30-40 Margaret Avenue Heritage Impact Assessment

Architectural Conservancy of Ontario North Waterloo Region branch

Presentation to Heritage Kitchener, June 4, 2019

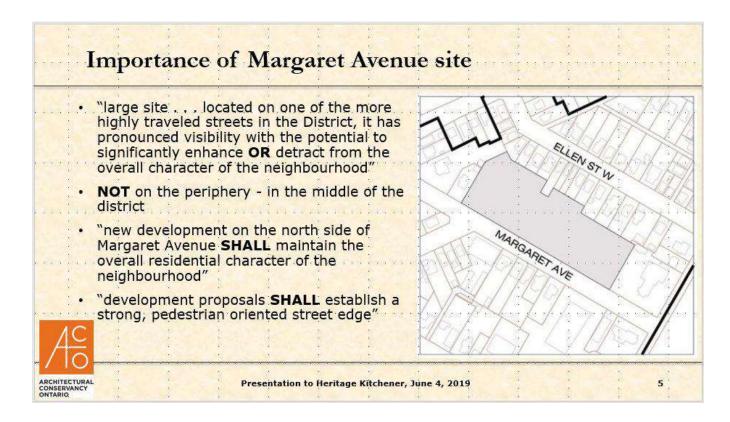
Policy	Response	Rebuttal	m
maintain the overall residential character of the neighbourhood	#1 - architectural details such as stepbacks and landscape features	steep mansard roof with corner terraces is not sufficient mitigation	
be of a height, siting and design which will prevent it from encroaching on lower density dwellings	#3 - third, fourth and fifth storeys are stepped back from the first and second; the sixth level is within the mansard roof which minimizes the impact of the building's height	'stepback' on the front façade from a porch, not the exterior of the second floor, and sixth mansard-storey do not adequately minimize the impact of height	
establish a strong, pedestrian oriented street edge that is consistent with the residential character of the District	#4 - architectural elements such as stepbacks as well as incorporated architectural features	again, sixth mansard-storey does not establish a pedestrian oriented street edge through the use of appropriate height

I've prepared a chart to compare these site-specific policies with the HIA's responses. In each case, the HIA suggests proposed stepbacks are adequate to satisfy policy requirements. It proposes there are two types of stepbacks: (A) the third storey is stepped back from the second, and (B) the sixth level. The first 'stepback' on the front façade is from a porch, not from the exterior of the second floor, therefore not a stepback; and the second is a very minimal stepback in the form of a steep mansard roof with corner terraces. These do not adequately minimize the impact of height to prevent it from encroaching on lower density dwellings, nor establish a pedestrian oriented street edge through the use of appropriate height as the policies require.

Site Specific Design Guidelines - 6.9.1 Margaret Avenue

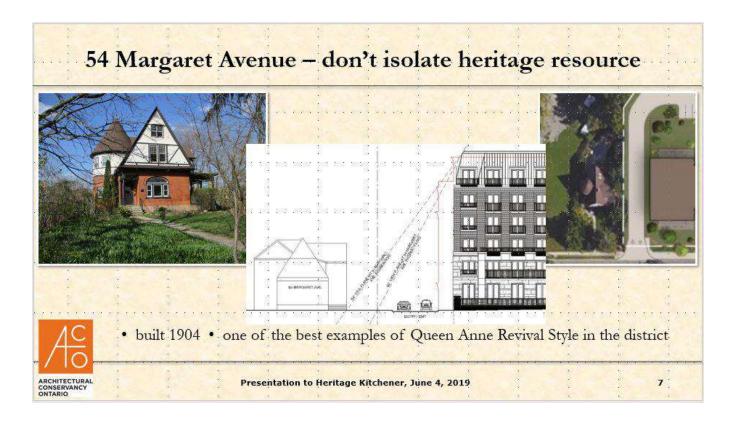
Response Rebuttal #10 - centred three storey glass atrium . . . floors above 3 to 4 storeys should each have a transition between three main building portions to continuous 2 m stepback - guidelines don't mention an angular plane of 45 degrees - two the east and west transitioned with two alternate stepbacks. Architectural elements alternate stepbacks = one at porch level, such as stepbacks and landscaping have also which is not stepback, and the other is on the been incorporated in order to demonstrate and sixth mansard-storey with corner terraces, enforce the pedestrian orientation of the building which are not continuous and its relationship with Margaret Avenue. The stepbacks meet the minimum requirement of 2 do not adequately minimize the impact of height on the pedestrian environment metres to provide useable terraces

• "building stepbacks are encouraged for any development greater than 3 to 4 storeys in height to minimize the impact of new development on the pedestrian environment of the street" – I interpret this to mean the floors above 3 to 4 storeys should each have a continuous 2 m stepback from the floor below – the guidelines don't mention an angular plane of 45 degrees as the HIA suggests, just "any development greater than 3 to 4 storeys" – the HIA suggests there are two alternate stepbacks, as I've outlined previously and suggested are insufficient. Therefore, I contend the development does not adequately minimize the impact of height on the pedestrian environment per this guideline.

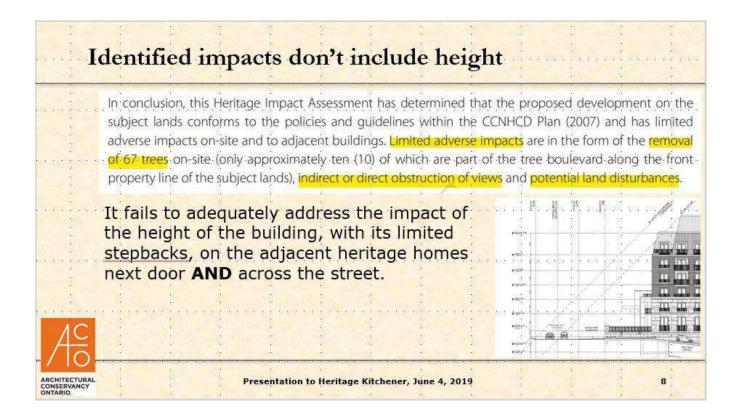
In this case, 54 Margaret is a Group A building, meaning it's one of the best examples of the heritage character of the District. We can't change the fact it's located between two new development lots. What we can do is ensure some mitigation of the impacts.

The HIA suggests the proposal will not isolate this heritage building. But the development is the width of the visitor parking driveway away from this historic home, a full five storeys in height with the very slight stepback in the sixth, mansard-storey. Stepbacks above the third floor or some other means must be used to mitigate this impact.
